NOTICE OF DENIAL

RE: Application Number 23-8238; 2200 East Atwater (2600) St.; Aretha Franklin Amphitheater/ Chene Park Historic District

CERTIFICATE OF APPROPRIATENESS

Site Assessment and Landscape Review For Plans Submitted By Hamilton Anderson Associates Inc.

EXISTING PYLON
SIGN TO BE
REMOVED.
LOCATION 05

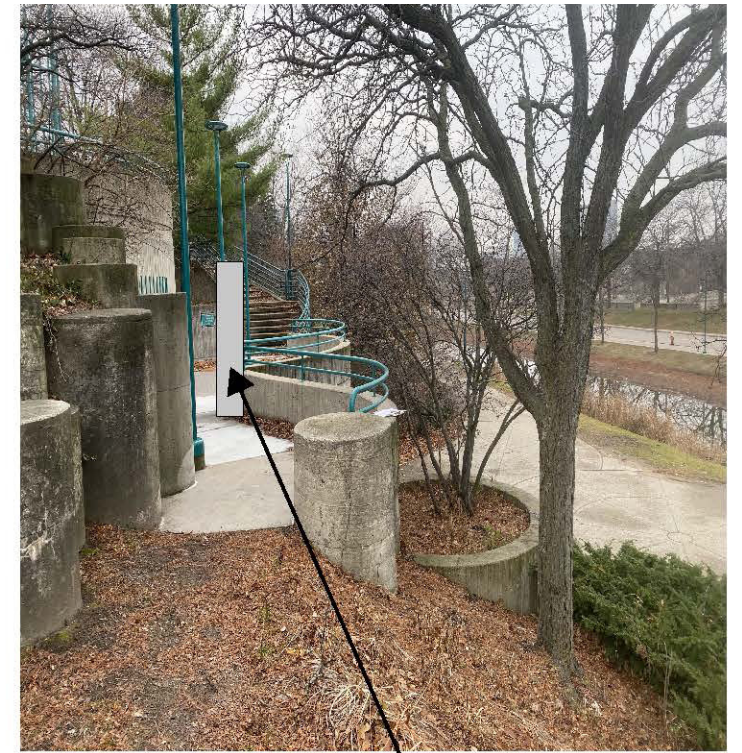
- ***The removal of the concrete pylons (#2, #5, #7, #11) per the applicant’s landscape plan.***

The Commission's reason for denial is that the proposed work will destroy architectural features that characterize the property.

- The pylons are integrated elements in the composition of the historic landscape and are contributing to the rhythm of and patterns of distinctive concrete features that are repeated and represented throughout the park, which are evident in from the largest architectural features down to the cylindrical break wall features, which together create a legible pattern language that as a whole is a key site design element.
- The materiality of the striated concrete at each pylon is characteristic of the architecture of this period and is also a distinct character defining feature..

Drawing Title
SITE DEMOLITION PLAN

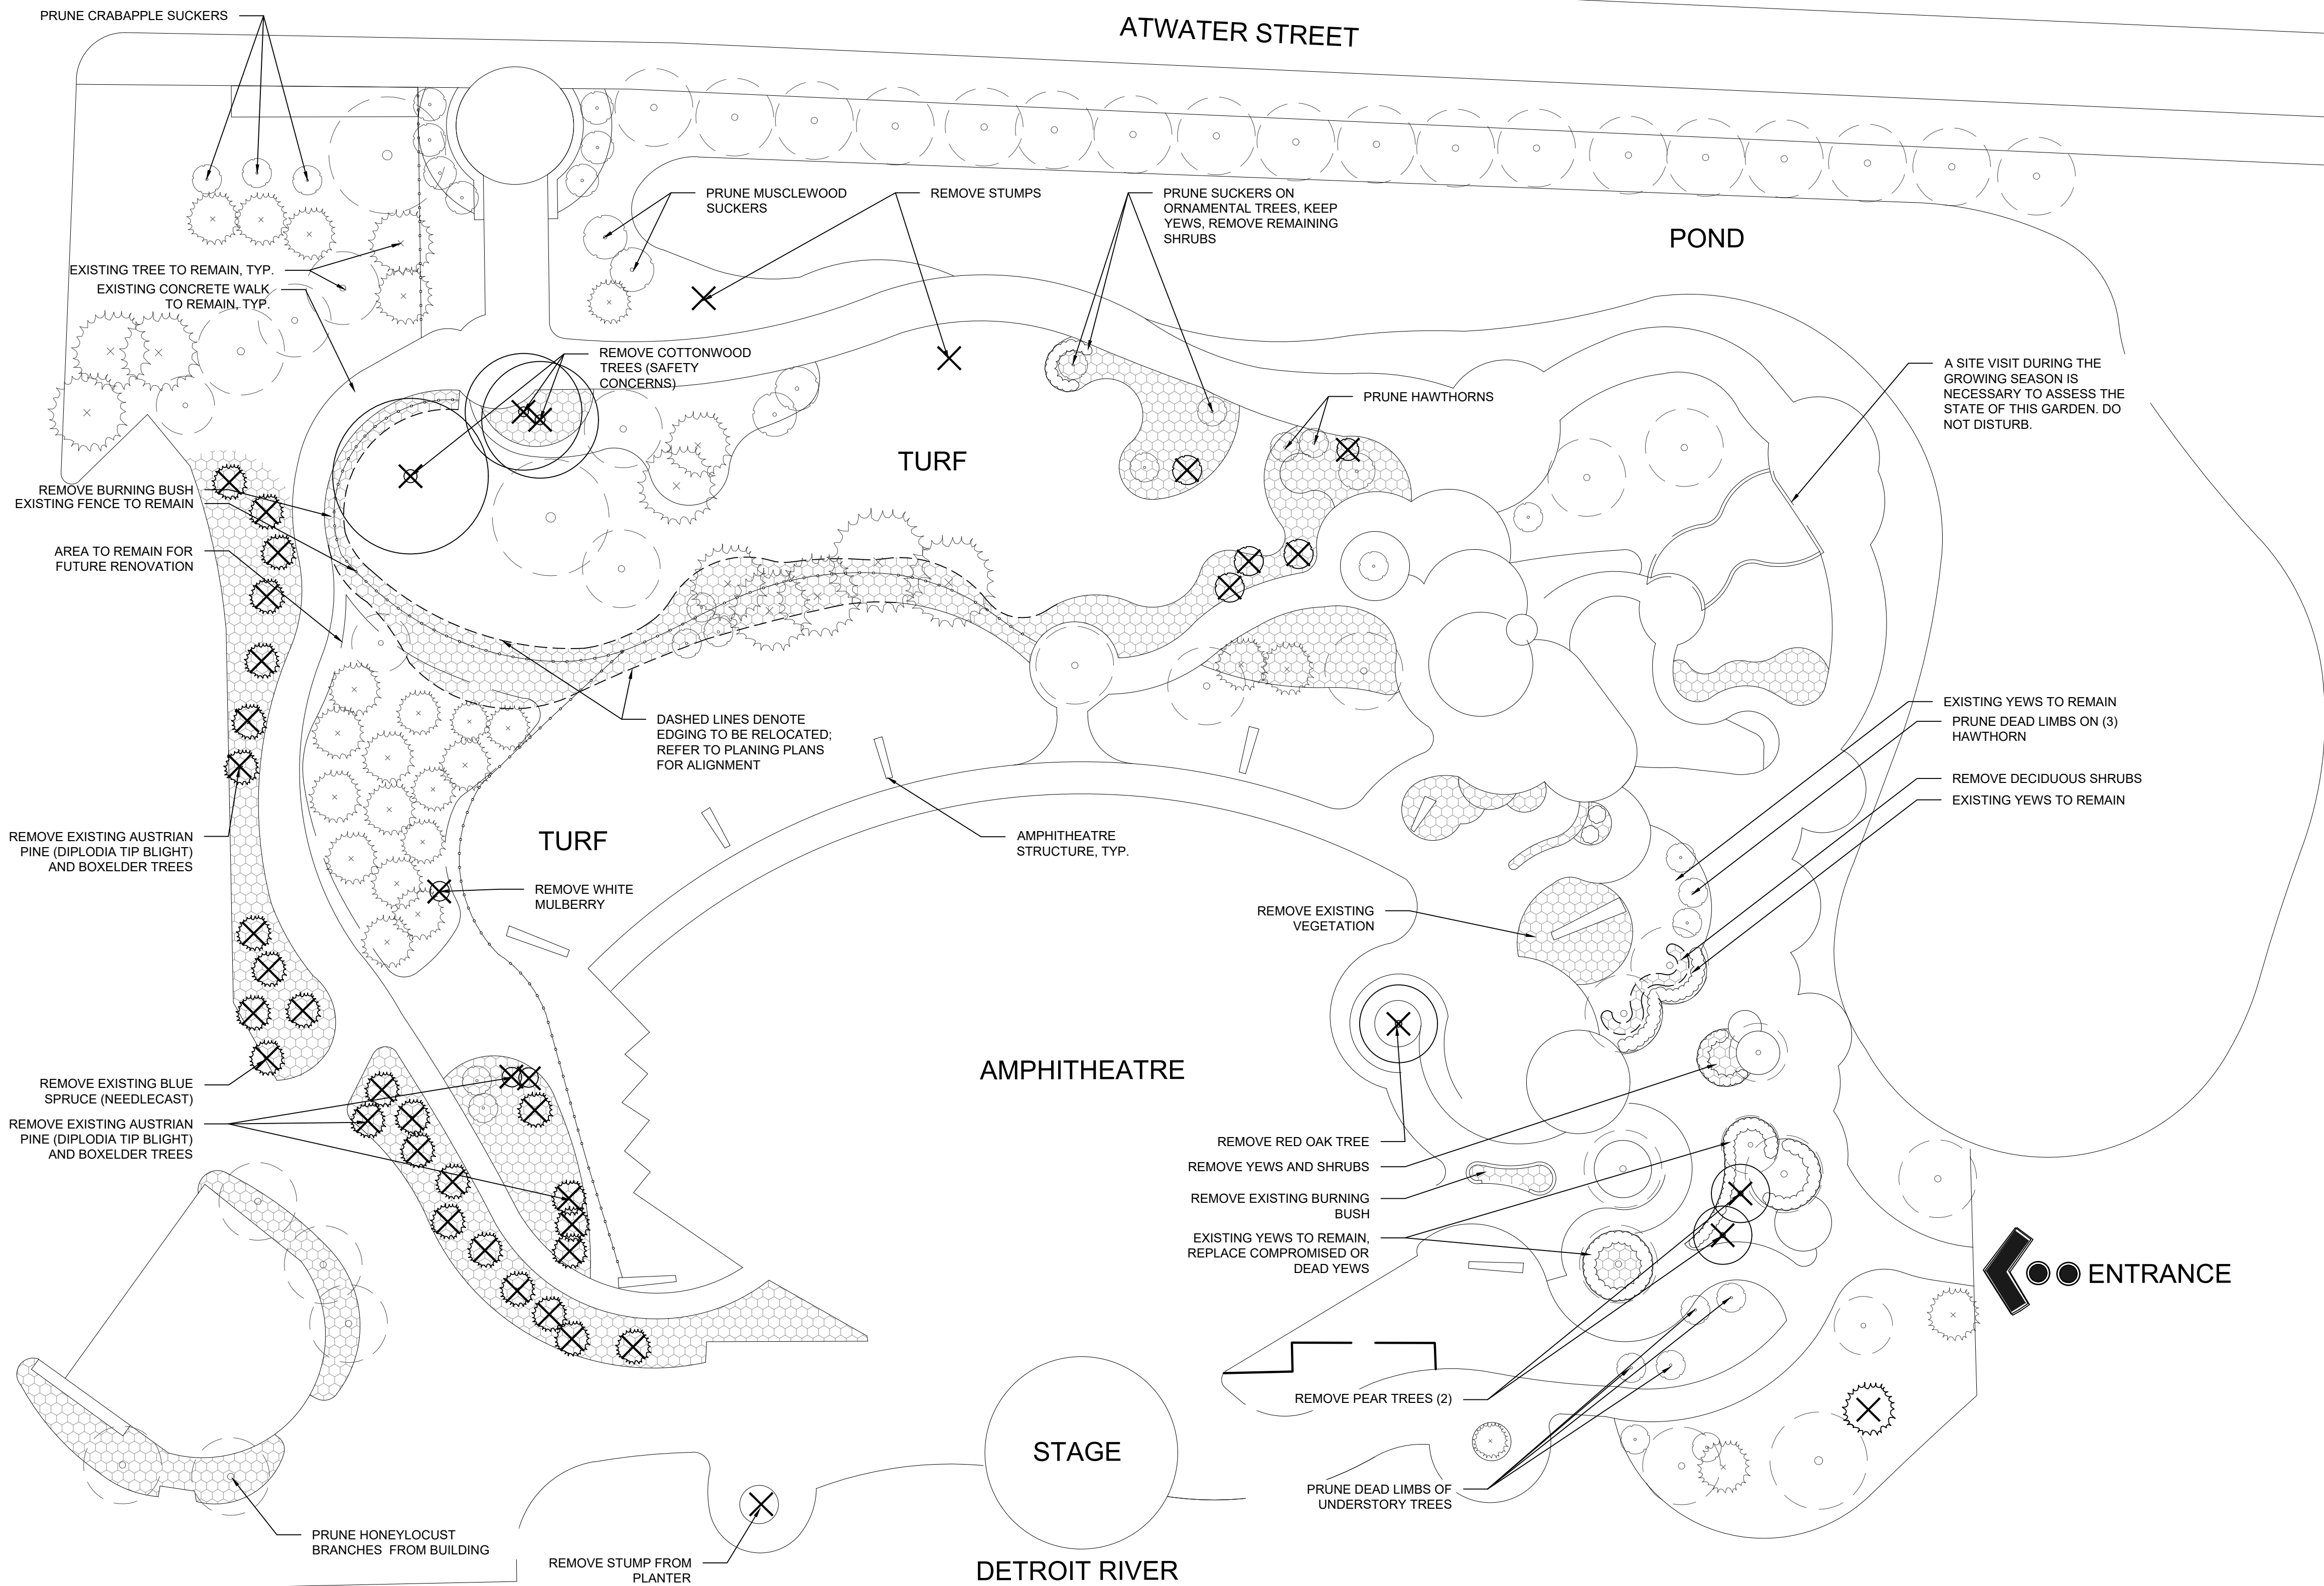
- a. The most extensive area for demolition of trees is on the west side of the amphitheater. It is recommended to complete these removals in order to stop diseases and pests from spreading any further. We also recommend beefing up the evergreen replacement plan and diversifying the species selection which, in addition to changes in the landscape management (irrigation) should prevent this kind of problem from happening again.
- b. On the north and east side of the amphitheater, the removals are mainly dead and dying shrubs with a few trees slated for demolition and the transformation with new plants will be very attractive, especially as the design is in keeping with the original design and actually has some improvements due to newer available cultivars of plants.

- B. Tree quantities
 1. As quite a few trees, over a dozen are slated for removal on the east side of the theater, please consider more replacements, closer to one for one in the new plan.
